Access Compliance Report

Public Rights-of-Way

(Pedestrian Signals)

Intersection ID: N/A	Main Street:	Cross Street: N/A	Location: N/A
ADA ID: F3633943DE83	Signal Type: One Push Button-Non APS	Overall Compliance: No	Severity Score: BTN 1: N/A BTN 2: N/A No BTN: N/A
Codes/Mitigation Info/Possible Solution		Field Measurements/Component Compliance

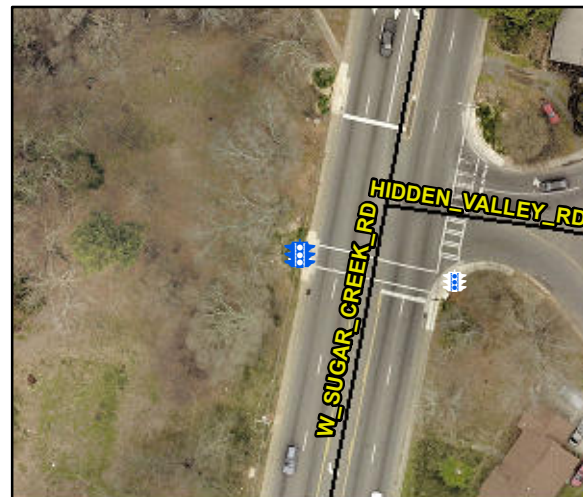
Surveyor Notes: TX HT 5/16

No	B 1 Clear Xing Direction?	NotClearlyMarked	N/A	B 2 Clear Xing Direction?	N/A
	B 1 Crossing Direction	To E		B 2 Crossing Direction	N/A
Yes	B 1 DistanceTo XWalk (in)	0.0	N/A	B 2 DistanceTo XWalk (in)	N/A
No	B 1 DistanceTo Curb (in)	73.0	N/A	B 2 DistanceTo Curb (in)	N/A
Yes	B 1 Diameter (in)	2.0	N/A	B 2 Diameter (in)	N/A

Possible Solutions: Replace Signal Push Button With APS Button on New Post. Remove & Replace Sign.
